NUMBER
CHA12017

Addendum Number: 01

REFERENCE EOI #CHA12017 COAL HERITAGE DISCOVERY CENTER

**Patteson Ford Building**  
**Mt. Hope, West Virginia**  
**Building site visit**  
**for**  
**National Coal Heritage Area**  
**Michael Gioulis June 25, 2008**

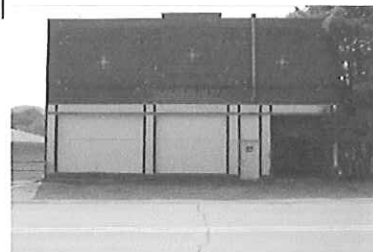
Question: Who developed the historic structures report and preliminary concept drawings?

Answer: Michael Gioulis - Attached is the preliminary concept drawing with some information on it.
